Groundwater Application Review Summary Form

Application # G- 19035

GW Reviewer Stacey Garrison/Travis Brown Date Review Completed: 2/17/2023

TO: Water Rights Section Date 2/17/2023
 FROM: Groundwater Section Stacey Garrison/Travis Brown
 Reviewer's Name
 SUBJECT: Application G- 19035 Supersedes review of 12/23/2021
 Date of Review(s)

Water-Level Measurements in Nearby Wells

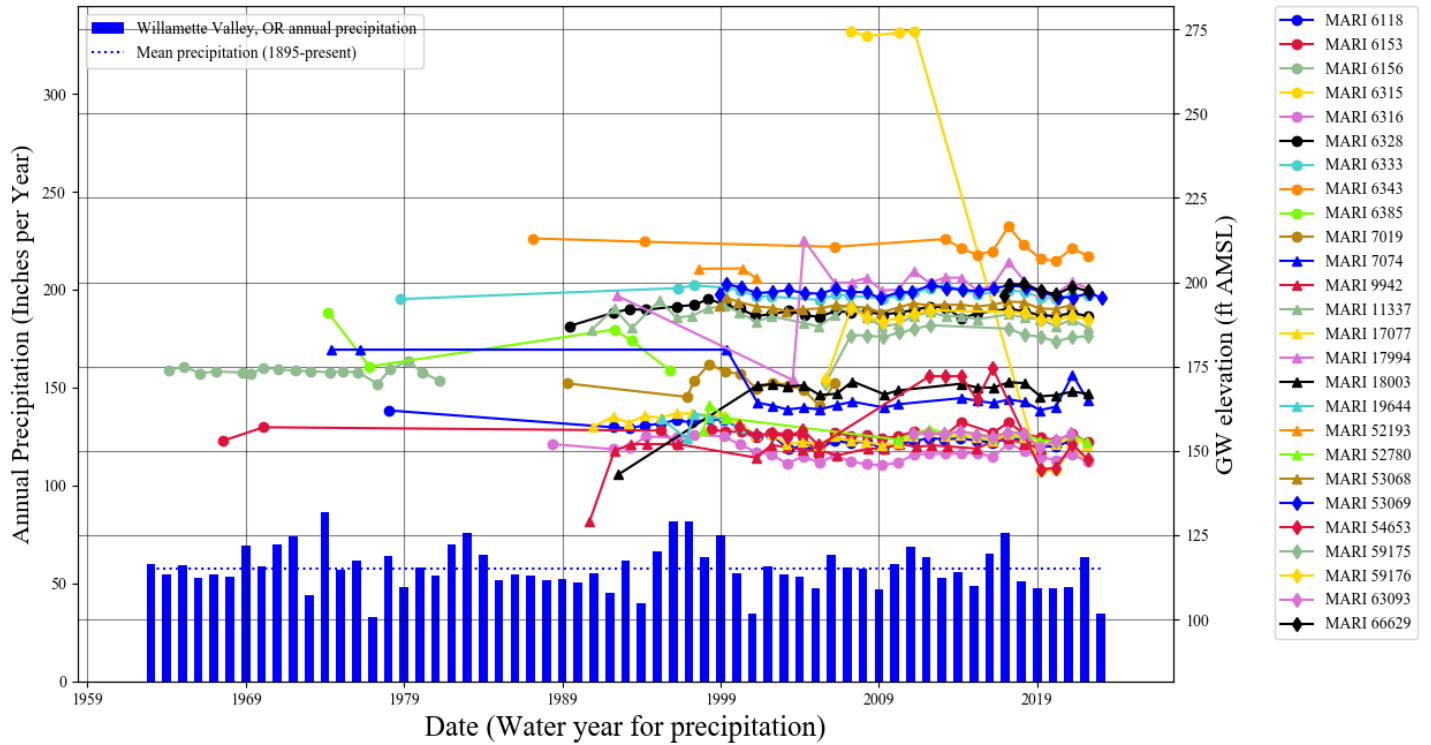
Water level trends for nearby wells that utilize the Late Tertiary Basalt Aquifers (LTBA) appear to be stable (see Water Level Measurements in Nearby Wells). MARI 6328, MARI 6333, MARI 17994, MARI 53068, MARI 53069, MARI 59175, MARI 59176, and the proposed POA (MARI 66629) have similar water level elevations and trends and are within 2 miles of each other, indicating they are likely within the same fault block. The overall trend of these wells is stable, with overall declines ranging from 4 to 40 ft: one well (MARI 17994) has experienced an overall decline of 41.5 ft; two of the wells have overall declines around 20 ft (MARI 59175 and MARI 59176); four of the wells and the proposed POA (MARI 66629) have had overall declines of less than 10 ft (MARI 6328, MARI 6333, MARI 53068, MARI 53069). A wider search of wells that utilize LTBA's within 2 miles of the proposed POA indicates 1 well (MARI 6315) meets two of the criteria for declined excessively; however, this well appears to be in a different fault block from the proposed POA. In addition, there are multiple quality concerns with the water level data from MARI 6315. There is not a preponderance of evidence to support that the groundwater reservoir utilized by the proposed POA is over-appropriated. Due to the compartmentalization of the CRBG aquifer and to ensure the perpetual use of the groundwater resource, permit condition 7i (Willamette Basalt Condition) is strongly recommended.

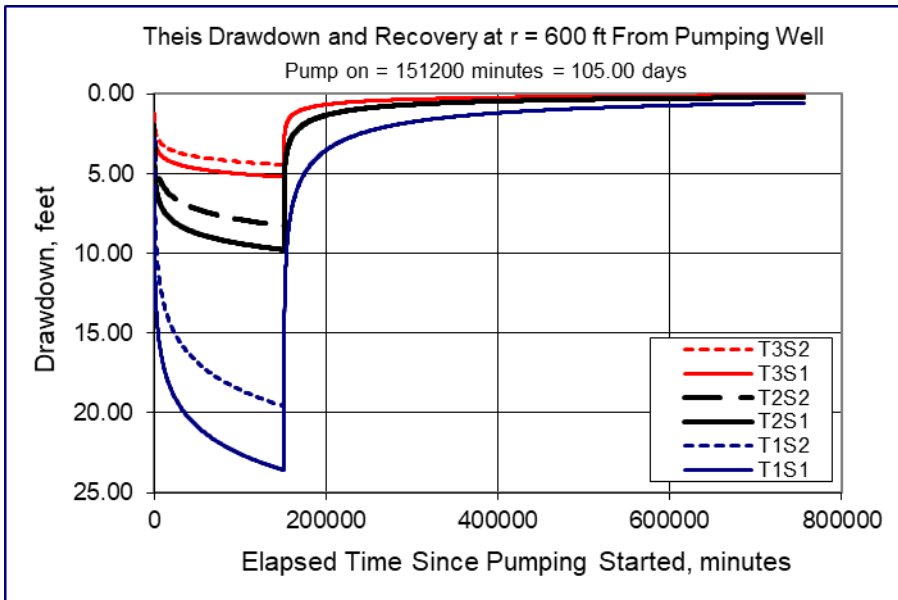
The nearest groundwater user (MARI 18030, an exempt domestic well) is ~600 feet northwest of the POA, at an elevation of ~274 ft msl. The well log does not record the latitude or longitude for MARI 18030, but it is recorded to be located on taxlot 400 at 10075 Sunnyview Road. Due to the domestic use indicated on the well log, it was assumed that MARI 18030 is co-located in the vicinity of the developed structures on taxlot 400 at 10075 Sunnyview Road. MARI 18030 is completed to a depth of 208 ft bls and has an open annular space of 85-208 ft bls (66-189 ft mls). The seal of the POA extends to ~43.5 ft msl, likely not sealing through the water-bearing zone that MARI 18030 is utilizing. It is likely the proposed use would cause some degree of well-to-well interference with MARI 18030. To assess the degree of drawdown, a Theis drawdown analysis was conducted for the proposed use (see attached Theis Drawdown Analysis). Results indicate that the proposed use is not likely to cause well-to-well interference with MARI 18030 that exceeds the threshold under the standard condition for basalt aquifers in the Willamette Basin. **Based on this analysis of the available data and under the assumptions previously identified, groundwater for the proposed use will likely be available in the amounts requested and within capacity of the resource; however, the conditions specified in B1.d. are strongly recommended to protect senior users and the groundwater resource.**

Radial distance from pumping well (r)=600 ft [estimated radial distance to nearest user, MARI 18030]

Pumping Rate (Q)= 0.708 cfs (317.75 gpm) [proposed rate]

Aquifer Transmissivity (T1)= 14,586 gpd/ft (1,950 ft²/day), (T2)= 38,896 gpd/ft (5,200 ft²/day), (T3)= 77,977 gpd/ft (10,424 ft²/day)

Storativity (s1) = 1 X 10⁻⁴, (s2) = 5 X 10⁻⁴ [Conlon et al 2005, Table 2 values for Central CRB]

Total pumping time = 105 days*

*The full pumping rate could not be utilized continuously for the entire 245-day irrigation season without exceeding the 147.75 ac-ft maximum allowed duty. For the maximum allowed duty of 147.75 ac-ft at 0.708 cfs, continuous pumping would occur for approximately 105 days.
